DOCKET 50-255 - LICENSE DPR-20 -
PALISADES PLANT - RESPONSE TO ADDITIONAL NRC QUESTIONS REGARDING ADEQUACY OF
STATION POWER

Consumers Power Company
Palisades Plant
CPCO-GWO-9062
Bechtel Job 12447-057
Palisades Battery Replacement
Project
OPERATION OF CLASS 1E BATTERY
CHARGERS AT VOLTAGES BELOW
432 VOLTS AC
File: 0275
81-12447/057-16

SCHEME NO K05

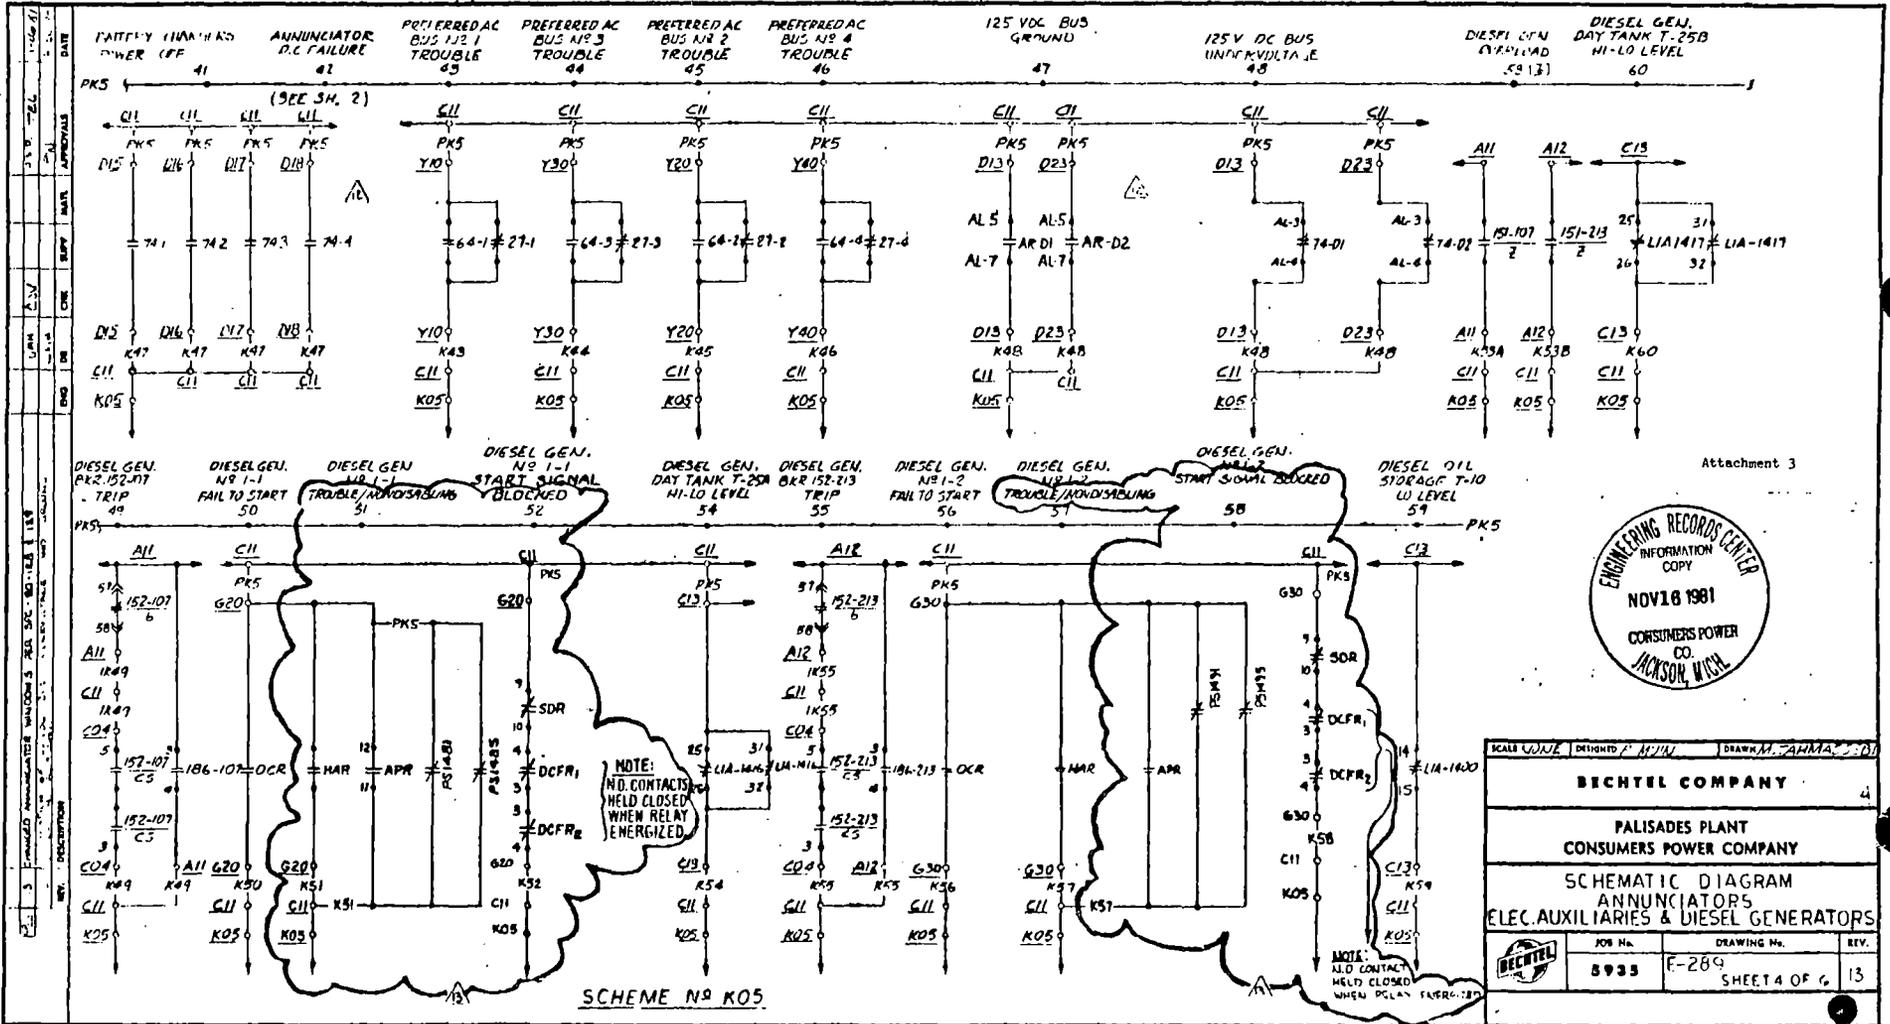
What is the setpoint of the "Battery Chargers Power Off" alarm? Is the alarm located in the control room?

As shown in Attachment #3, a contact in each battery charger (eg, Contact 74-1 in battery charger #1, Contact 74-2 in battery charger #2, etc) closes to annunciate a common alarm located at Panel C-11 in the control room. Each one

of these contacts is actually a part of its charger's electronic alarming device. Based on the vendor's instruction manual and on contacts with plant personnel and with Bechtel Associates, it is the opinion of the Consumers Power Company that these electronic devices generate the control room annunciation whenever their respective charger's output drops to 105V d-c. To confirm this opinion, the Consumers Power Company plans to test one of these devices at its earliest opportunity. In addition, the Consumers Power Company plans to add these devices to the plant's routine maintenance program.
